Airspace Change Proposal - Operational Assessment

<b>Title of Airspace Change Proposal</b>	<b>Neart Na Gaoithe and Inch Cape Transponder Mandatory Zone (TMZ)</b>
<b>Change Sponsor</b>	<b>Neart Na Gaoithe Offshore Windfarm Limited (NNGOWL) &amp; Inch Cape Offshore Limited (ICOL) - assisted by Osprey Consulting Services Limited (OCSL)</b>
<b>AR Project Leader</b>	<b>[REDACTED]</b>
<b>Case Study commencement date</b>	<b>Planned: 12 Oct 15 (Doc Check 5 - 12 Oct 15)</b>
<b>Case Study report as at</b>	<b>1 April 2016</b>

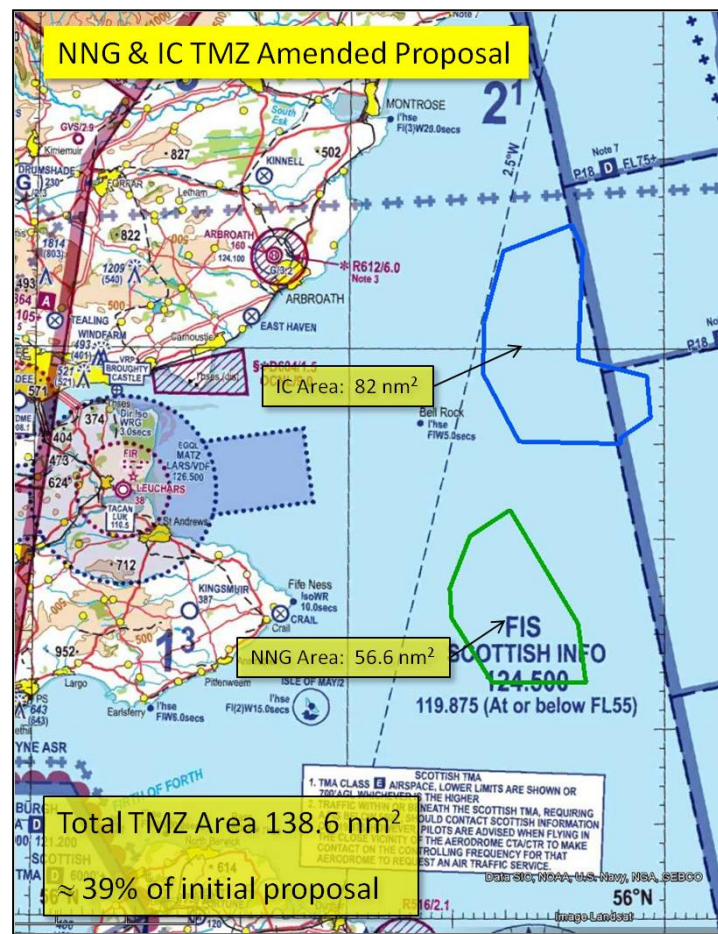
Based on this, any occasional requirement to mitigate navigation errors appears not to justify the imposition of such a large buffer zone around each windfarm. However, it is accepted that radar diffraction at the WTGs can generate a radar shadow (blind spot) for a few hundred metres (CAP 764, p28, para 2.21) that might hide very small objects. It is therefore appropriate to accept that a 1nm buffer zone on the eastern (shadow) side of each development would be appropriate.

**Thirdly**, the proposal seeks to encompass both windfarms within a single TMZ. This has been justified on the basis that single windfarms (including individual buffer zones) would be so close together they would be difficult to resolve visually on a radar screen. The proposed argument also states that, from the air pilots would find it difficult to visually resolve the windfarms. However, the closest distance between WTGs at each site would be 6.1nm without extensive (2nm+) buffer zones around each development. This larger distance could be resolved by radar and the type of aircraft likely to operate in the area would be able to navigate to this level of accuracy, either visually or when IMC. Therefore, the proposal provides little evidence to justify encompassing both windfarms within a single TMZ.

**In summary, there is very little evidence to justify the introduction of the large (359 nm<sup>2</sup>) proposed TMZ and buffer zone described in the proposal as the most suitable option.**

Following discussions with the sponsor and MOD, it was agreed that a revised solution would still meet the MOD's requirement to mitigate the effects of the clutter. The revised and agreed solution would be two separate smaller TMZs around each windfarm. The TMZ boundaries will be dictated by the accuracy of the radar blanking. A 1nm buffer area will be included within the TMZ on the eastern

boundary of each windfarm to cater for the known radar shadow effects. The footprint for this two windfarm solution would be a combined area of approximately 138.6 nm<sup>2</sup>; 39% of the original proposed solution. This revised solution represents a compromise between mitigating the well-documented impacts of the windfarms and minimising the volume of airspace to be reassigned. The original proposal and the revised proposal are shown below. It should be noted that the exact revised boundaries may need to be refined very slightly as the developers make detailed decisions on the location of each WTG.
